Application for Plan Review

OVERHUS DINING ROOM ADDITION

Fire Marshal Division

**Re: Overhills Dinning Hall Addition
2495 Ray Road
Spring Lake, NC 28390**

001.1 LIFE SAFETY PLAN
SCALE: 1" = 20'-0"

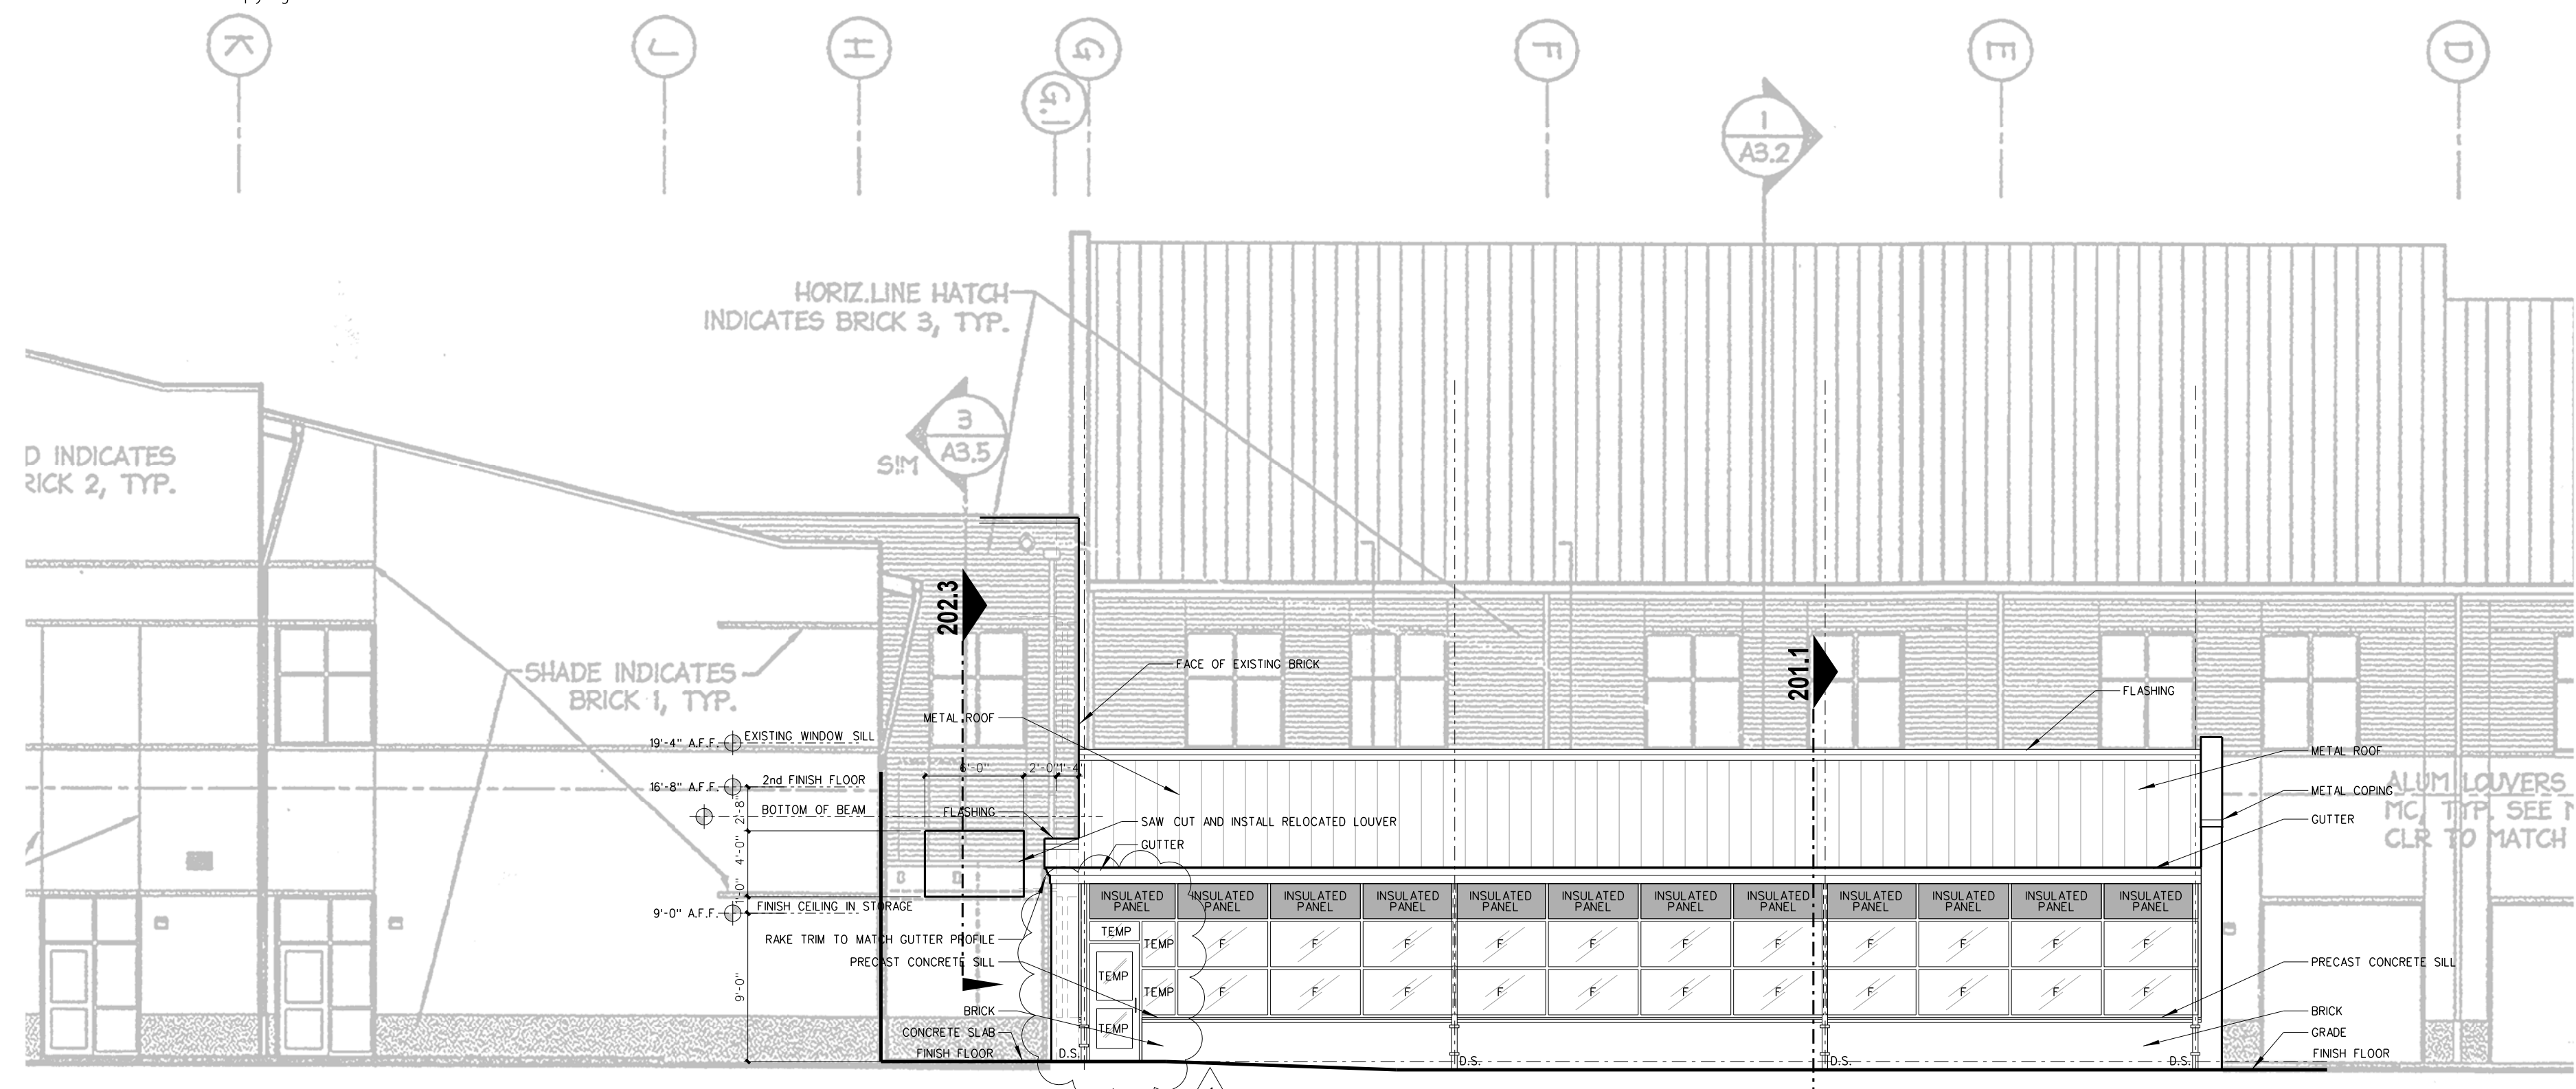
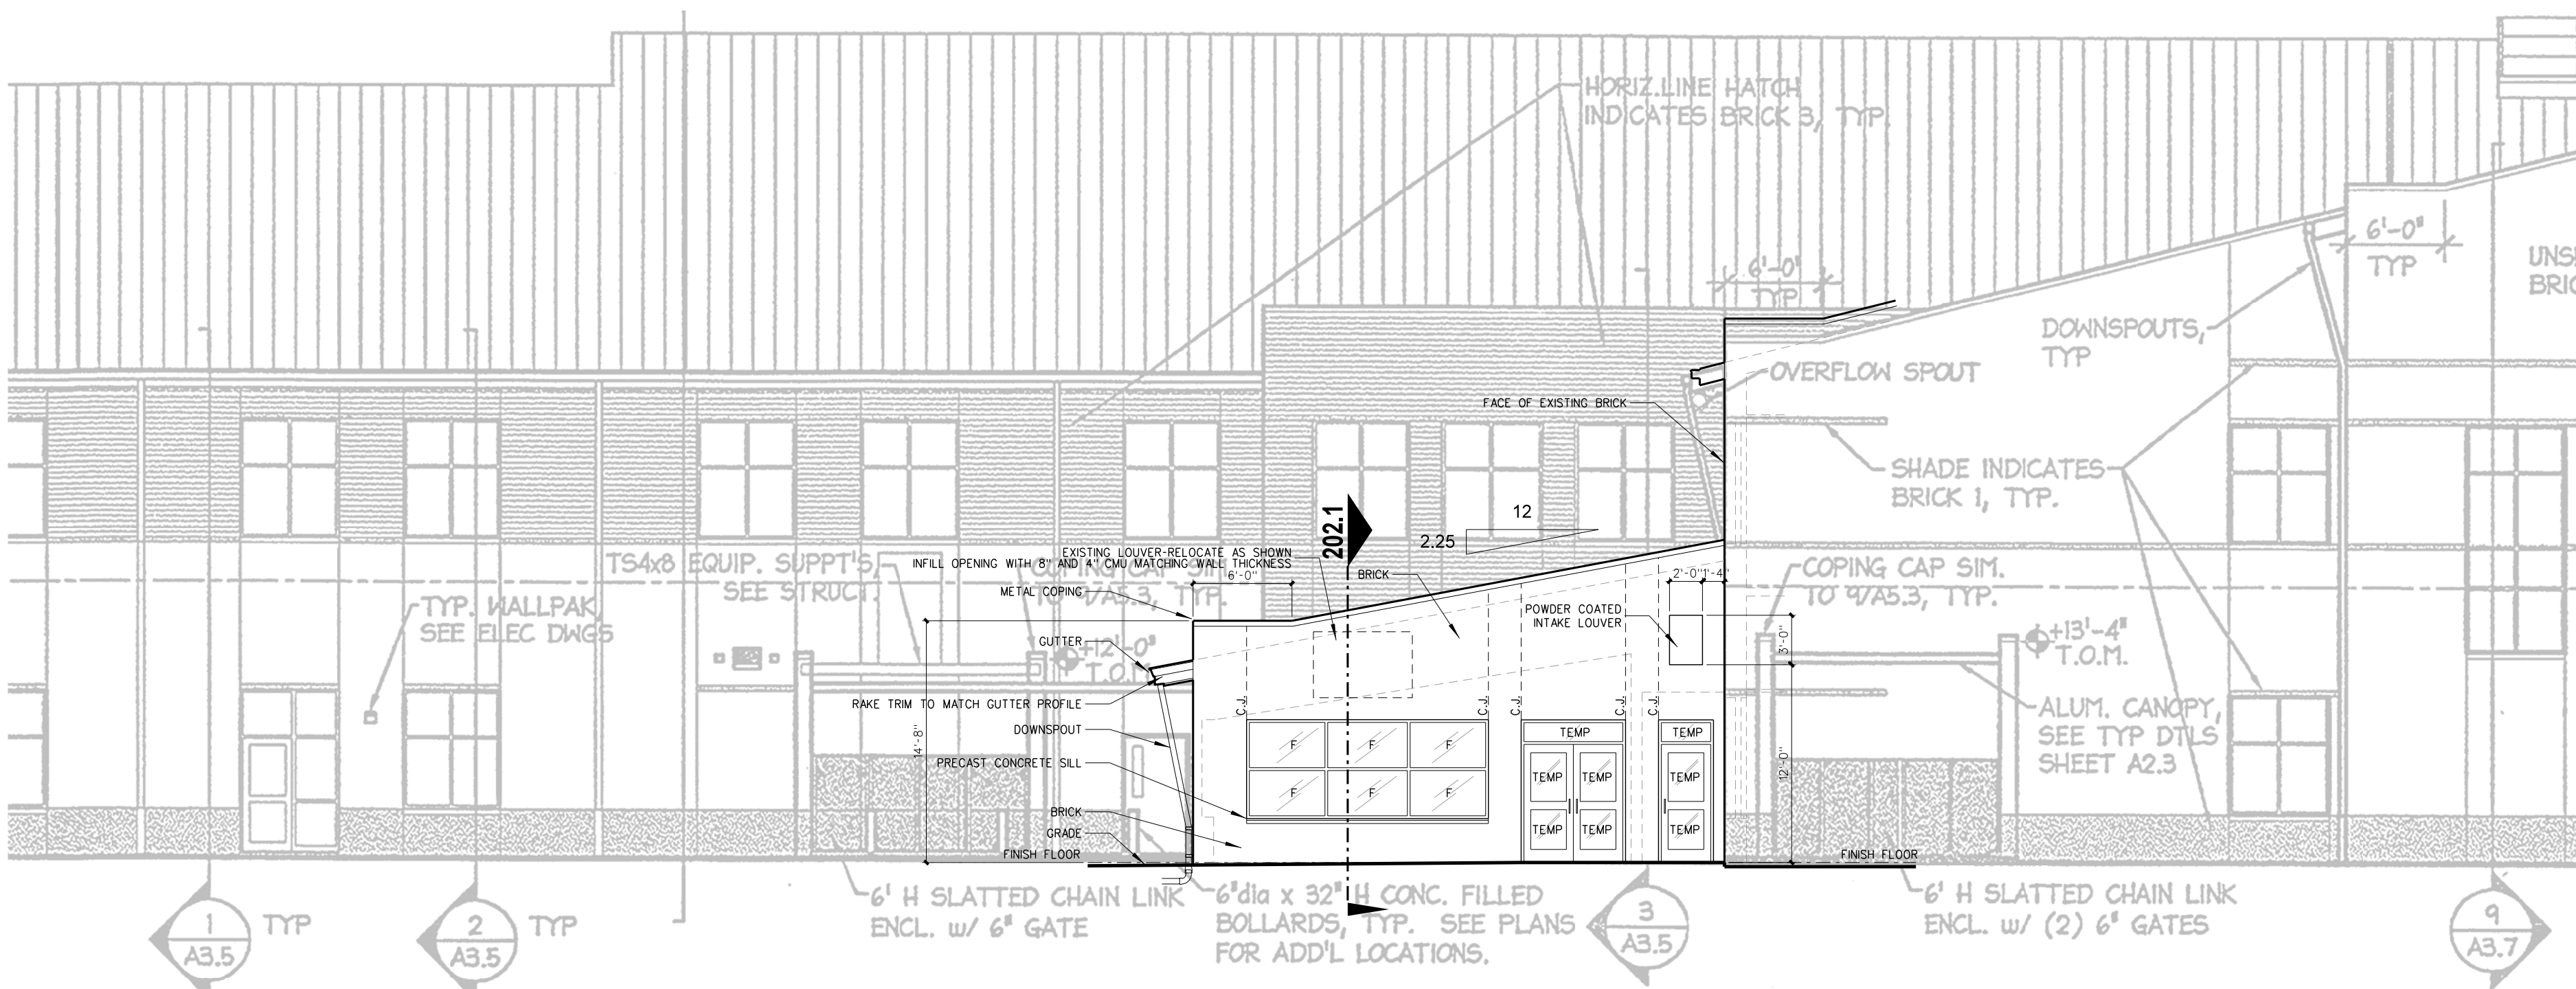
I have asked the architect for the total number of occupants egressing from the existing dining area through the addition. Also, the total travel distance of the occupants egressing from the existing dining room through the addition. As soon as we get this information we can complete the review.

The total number of occupants egressing from the existing dining area through the addition = 51 persons

The total travel distance of the occupants egressing from the existing dining room through the addition = 115 feet
